Montana Department of Transportation

Subject: Ronan-Urban Re-evaluated Final Supplemental Environmental Impact Statement and
Final Section 4(f) Evaluation (for the Ronan-Urban segment only)
Project No. NH-MT 5-2 (153) 45
Control No. 1744013

The purpose of this letter is to request FHWA concurrence that the following proposed design changes, changed conditions and updated environmental information would not result in significant changes that would require preparation of an additional SEIS. The request for FHWA action pertains only to the Ronan-Urban improvements (RP 44.6 to 48.7).

FIGURE 3.2-16. Typical urban roadway cross-section for a four-lane roadway with raised landscaped median or with continuous two-way, left-turn lane.

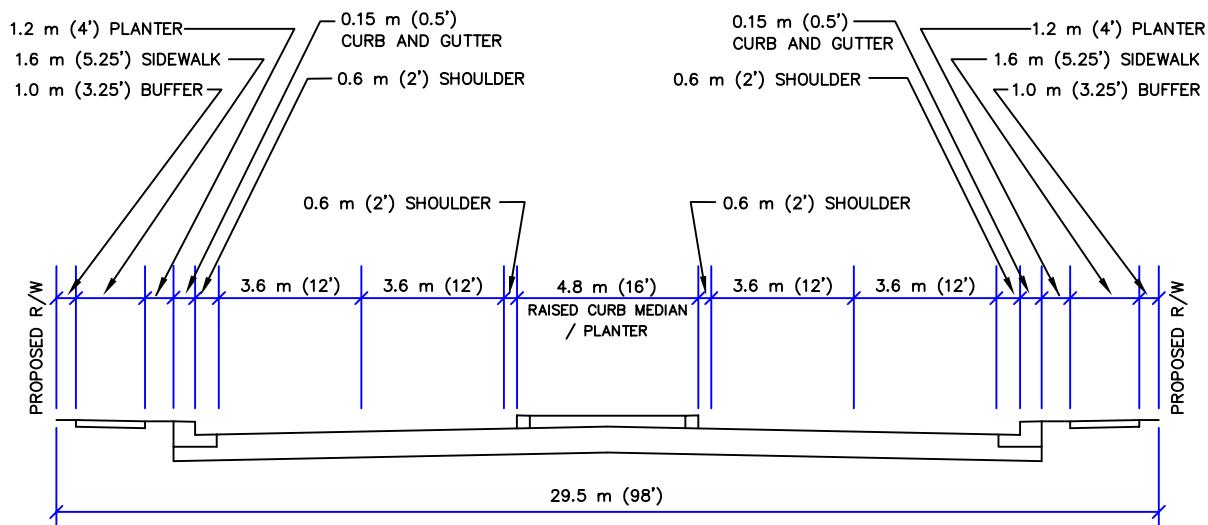
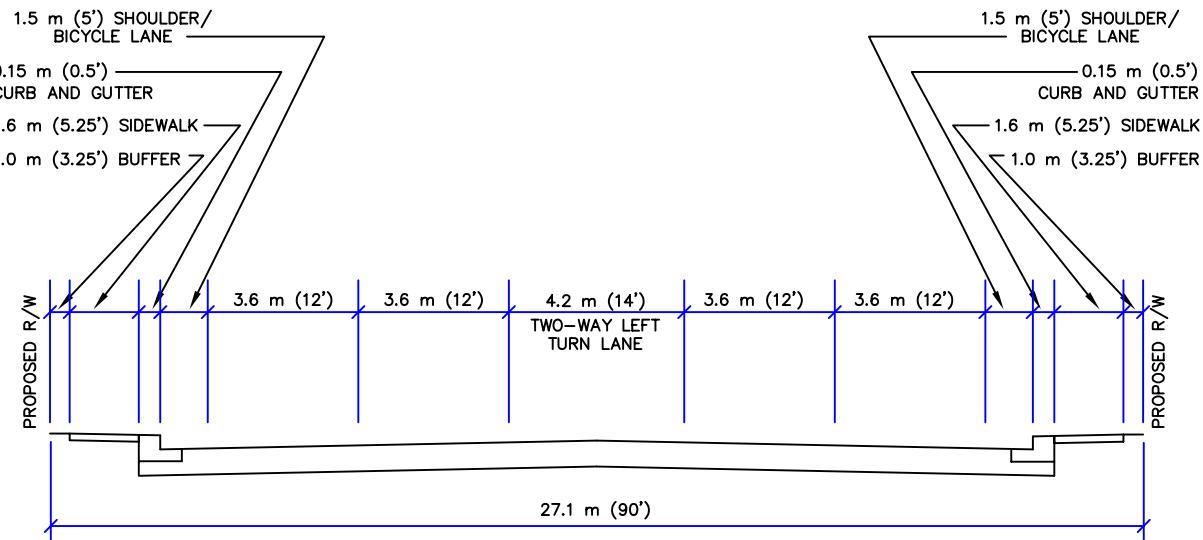
SEIS Figure Correction: The 2008 Final SEIS included one figure incorrectly which is disclosed herein. This drawing was **Figure 3.2-16** in the Draft SEIS but was inadvertently replaced with an incorrect drawing in the Final SEIS. The correct Figure 3.2-16 is shown in **Attachment 2** and includes the typical sections for the four-lane with raised landscaped median included in the Ronan Alternative 1 and the four-lane with continuous two-way left turn lane included in Ronan Alternatives 2, 3, and 4. The lower portion of this figure shows the preferred urban alternative and is being used for design guidance on the Ronan-Urban project.

Design Change Locations Attachment 4

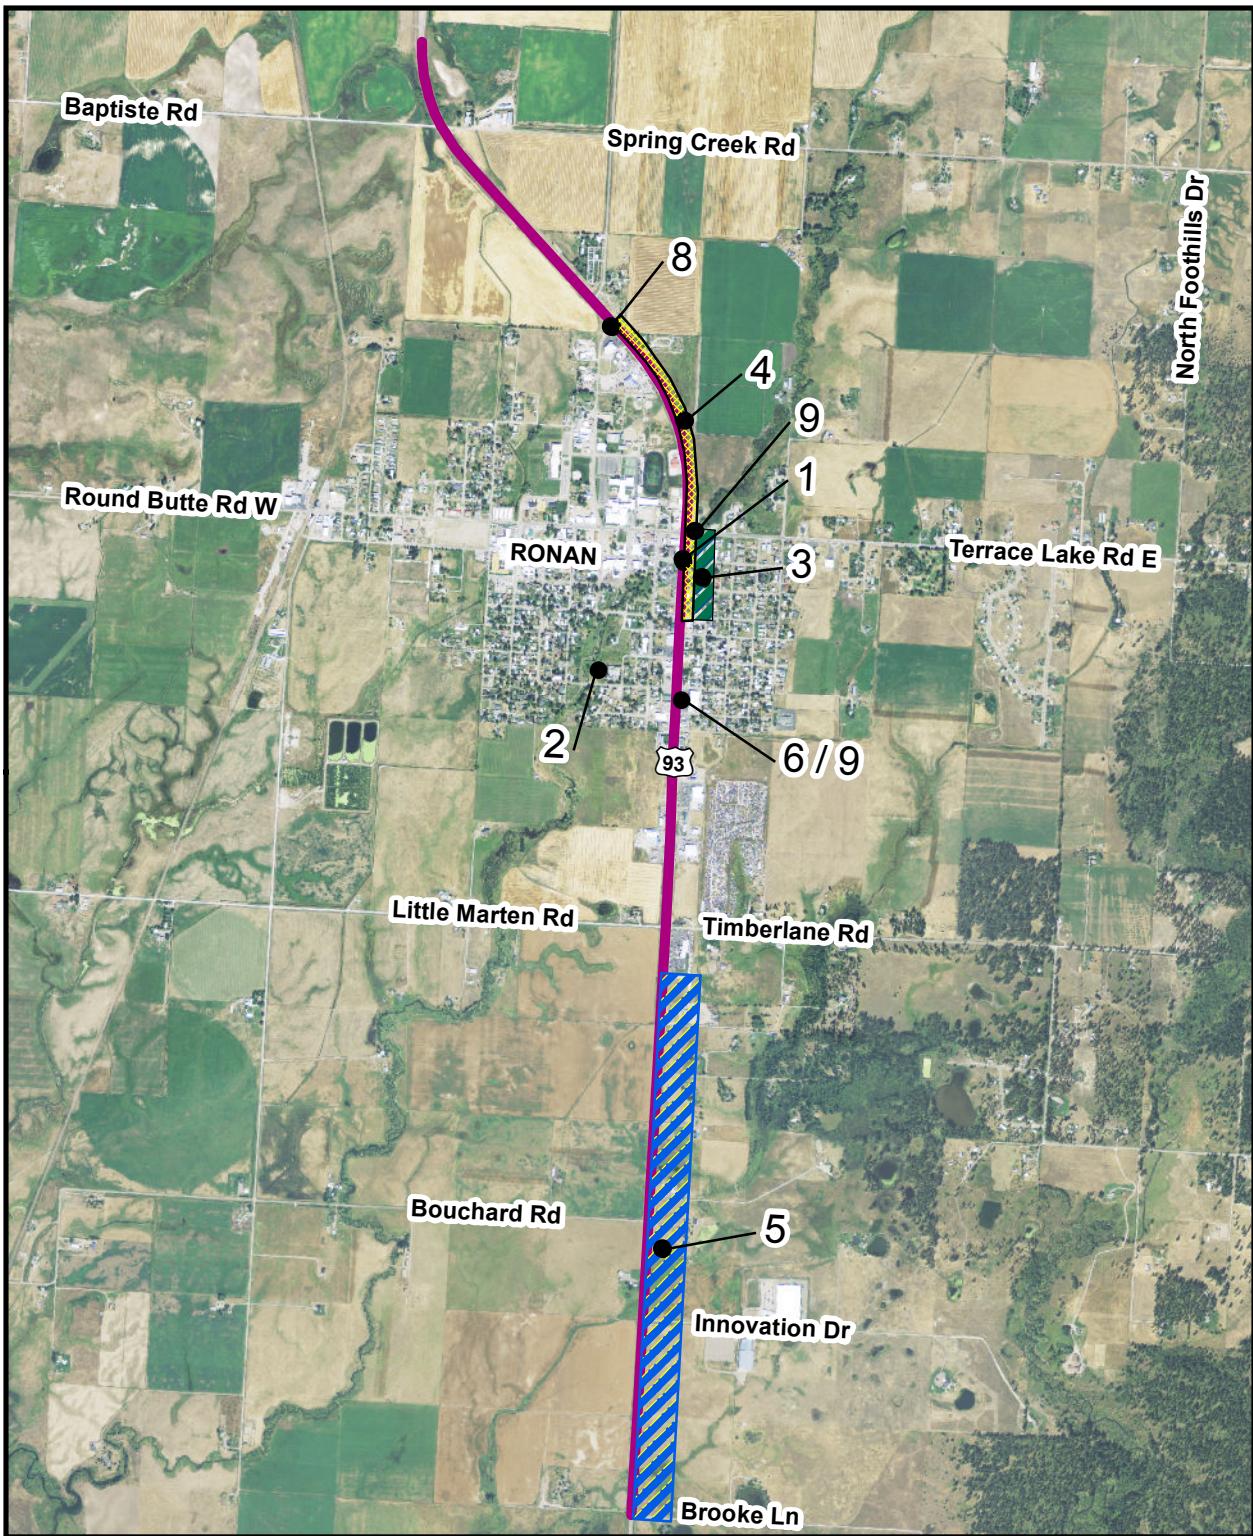
Design Change 5 proposes a five-lane road section with a center, left turn lane from Brooke Lane to the south Ronan City Limits (RP 44.6-46.0) at the location shown in **Attachment 4**. The pavement width would be revised from two, 36-foot paved roadways separated by a minimum 40-foot median to a single paved width ranging from 68- to 80-feet. The proposed 14-foot center turn lane would allow emergency, private and public access for all parcels, from both directions of travel. In 2013, MDT met with the CSKT and the Technical Design Committee (TDC) who both supported the change to omit the open median and replace it with a center turn lane.

Design Change 8 would install a traffic signal at the reconstructed intersection with US 93 and Old US 93 (location shown in **Attachment 4**) which would provide a fully-actuated bicycle/pedestrian crossing of US 93. The City and local community voiced strong support for installation of a traffic signal at Old US 93. The SEIS identified a potential for this traffic signal (page 3-50).

DATE: JUN 2007
SHEET NUMBER 9 OF 11

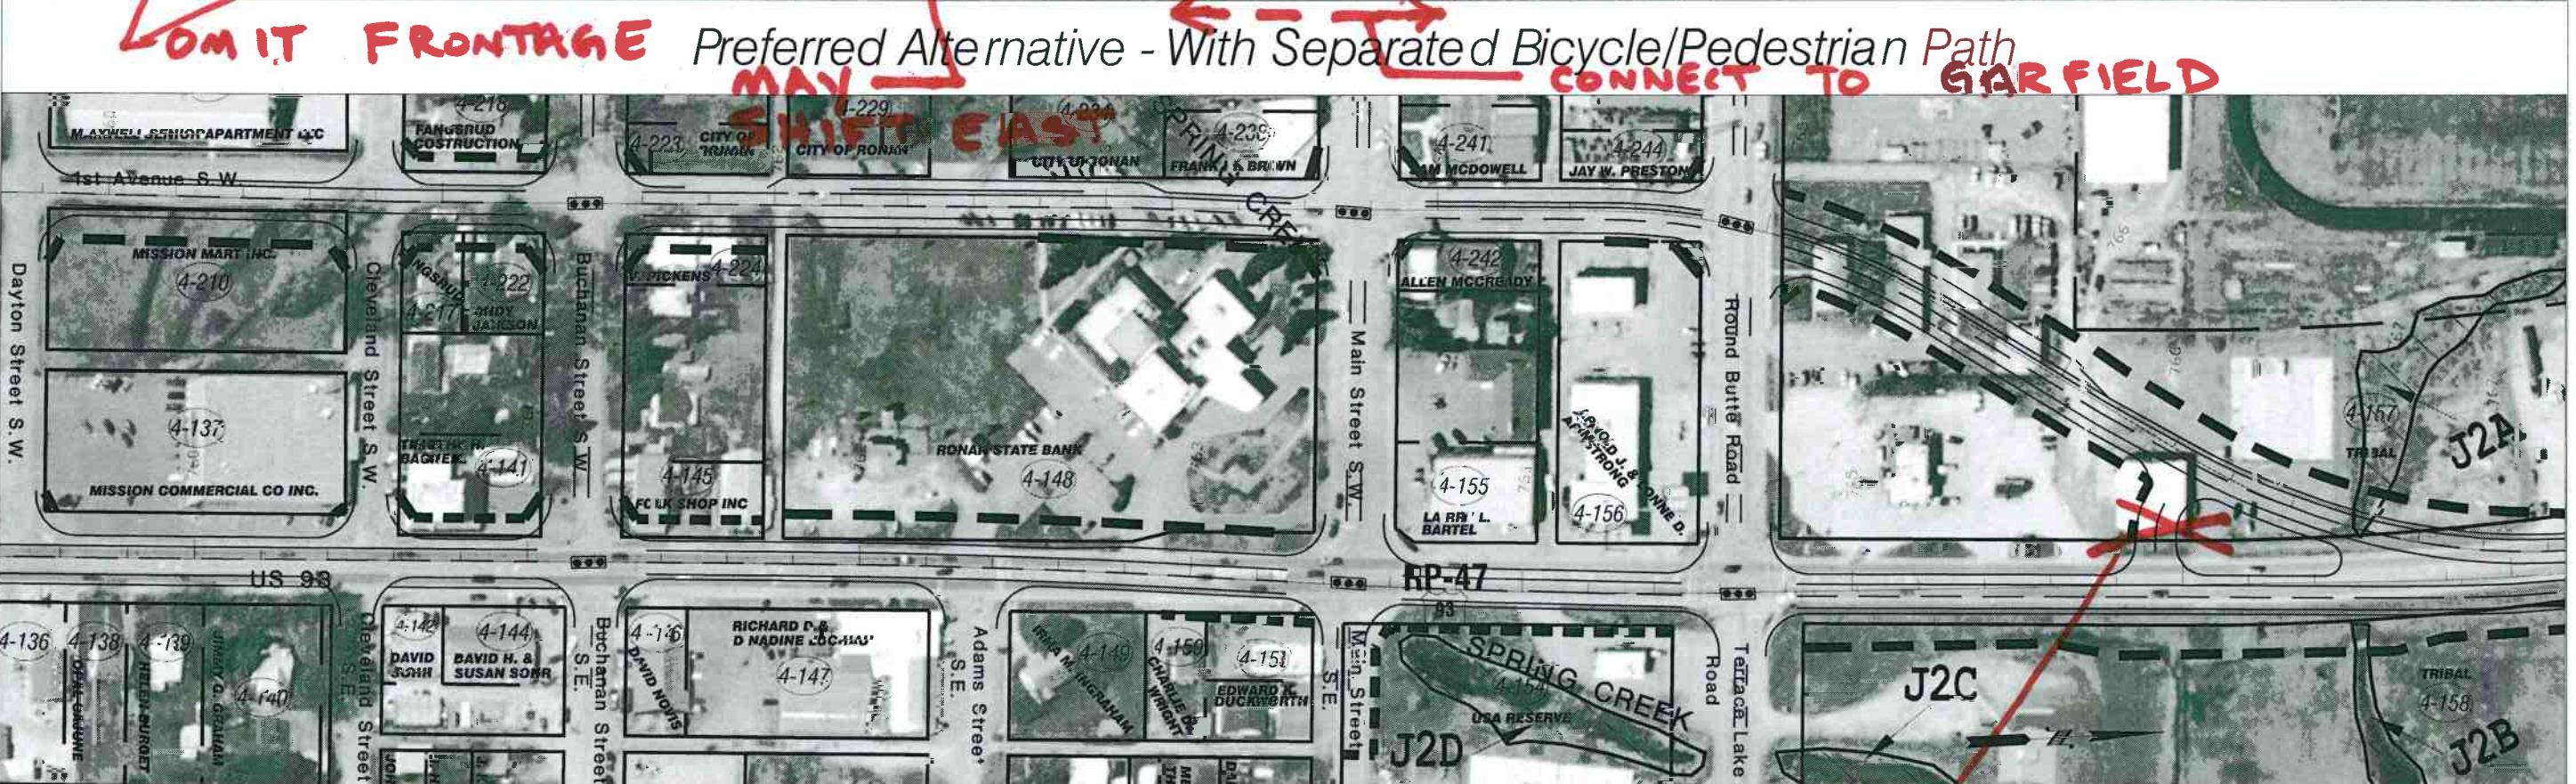
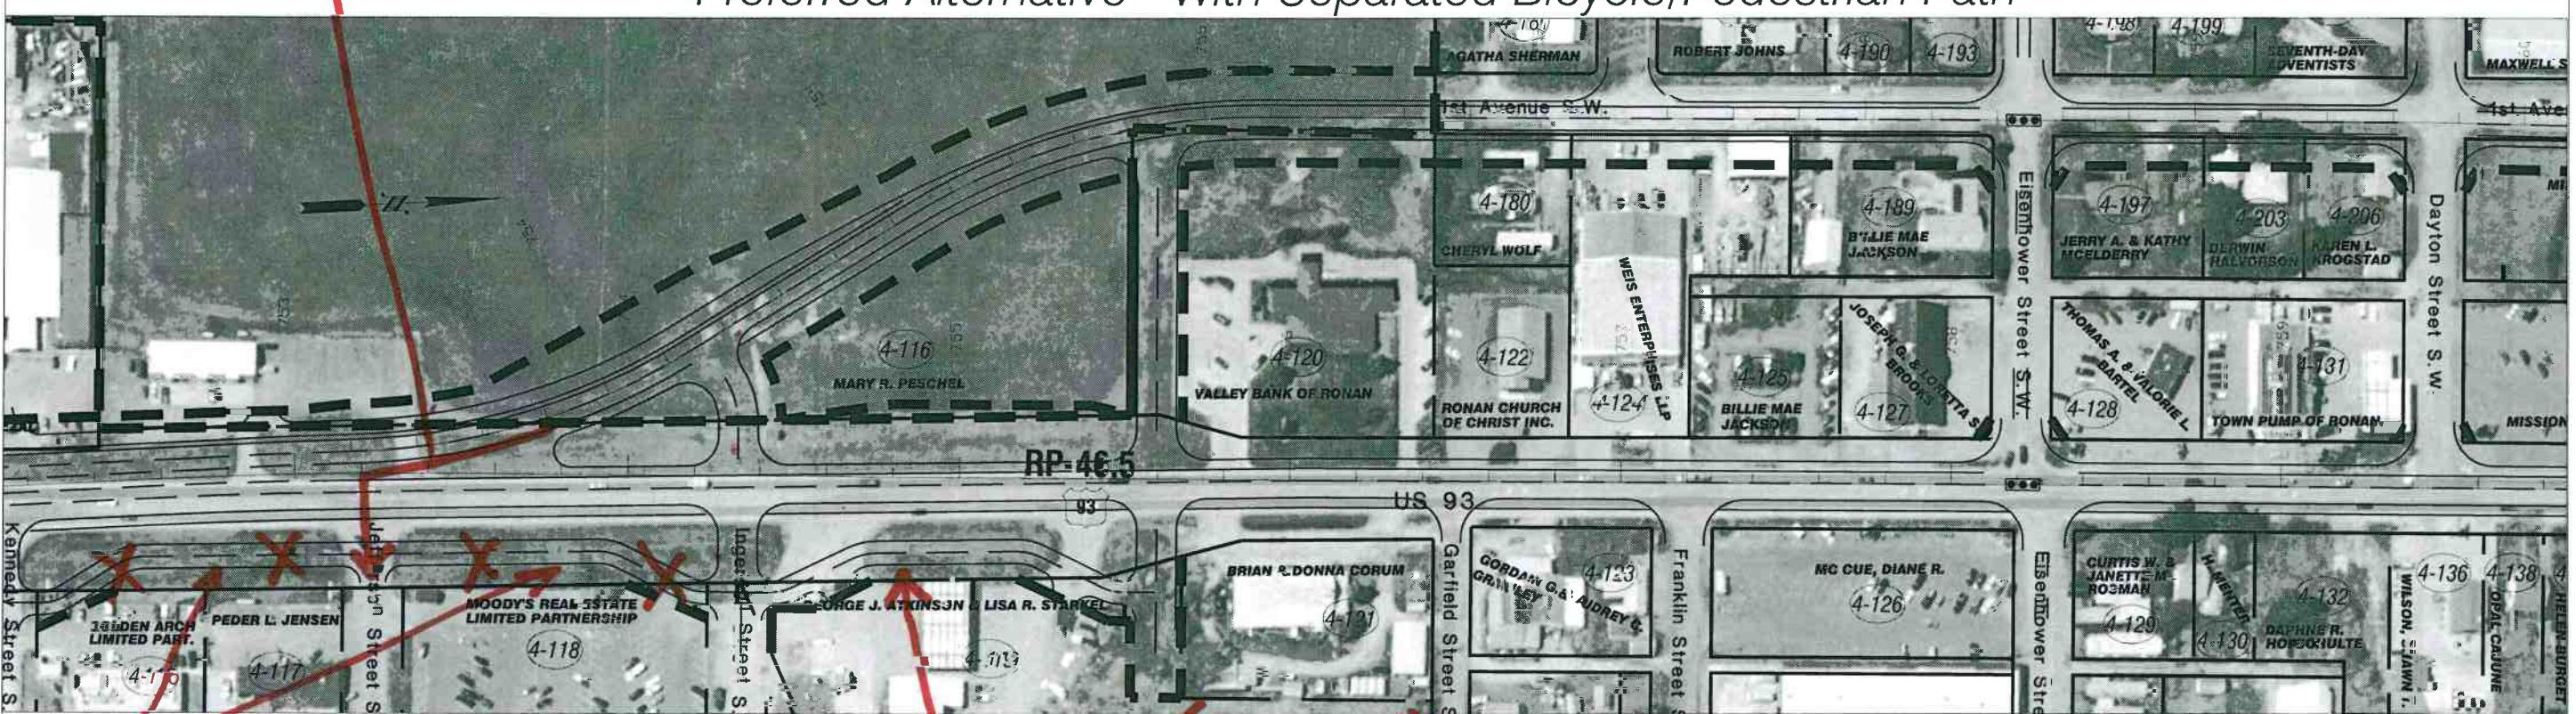
The 2008 SEIS identified an eastside Frontage Road between Kennedy and (future) Harrison Streets to provide access to east-side commercial parcels, in the transition area to the one-way couplet (Sheet 9, of Appendix E from the SEIS).

As a result of landowner and City discussions that identified the need to provide a north-south connection to the City's road network in the couplet transition area, Design Change 6 will extend the Frontage Road one-block north to Garfield Street in the area shown in **Attachment 4**. To improve mobility and safety along the improved route without creating a barrier dividing the Ronan community (page 2-5 of the SEIS), Design Change 6 will modify the proposed road connections to reduce the potential for vehicles queuing or blocking traffic on the one-way couplet and improve local access. Further Frontage Road modifications are also discussed under Design Change 9, below.

The 2008 SEIS shows short connection roads at the couplet transition locations (Sheet 9, Appendix E from SEIS). Preliminary traffic analysis showed these connections could generate traffic queues (due to inadequate storage space) and additional impacts to the commercial properties adjoining the Frontage Road.

As a result of landowner meetings and traffic analysis that identified congestion issues, Design Change 9 will modify roadway connections identified in the SEIS (Sheet 9 of Appendix E) to improve mobility and safety along the improved route without creating a barrier dividing the Ronan community (page 2-5 of the SEIS). The modified road connections would reduce the potential for vehicles queuing or blocking traffic on the one-way couplet. The changes (shown in **Attachment 6**) include omitting the north couplet connection road, changing the south couplet connection road (at Jefferson Street) to one-way, eastbound flow, connecting the proposed Frontage Road to the local road system (Design Change 6) and eliminating portions of the Frontage Road between Kennedy and Harrison Streets.
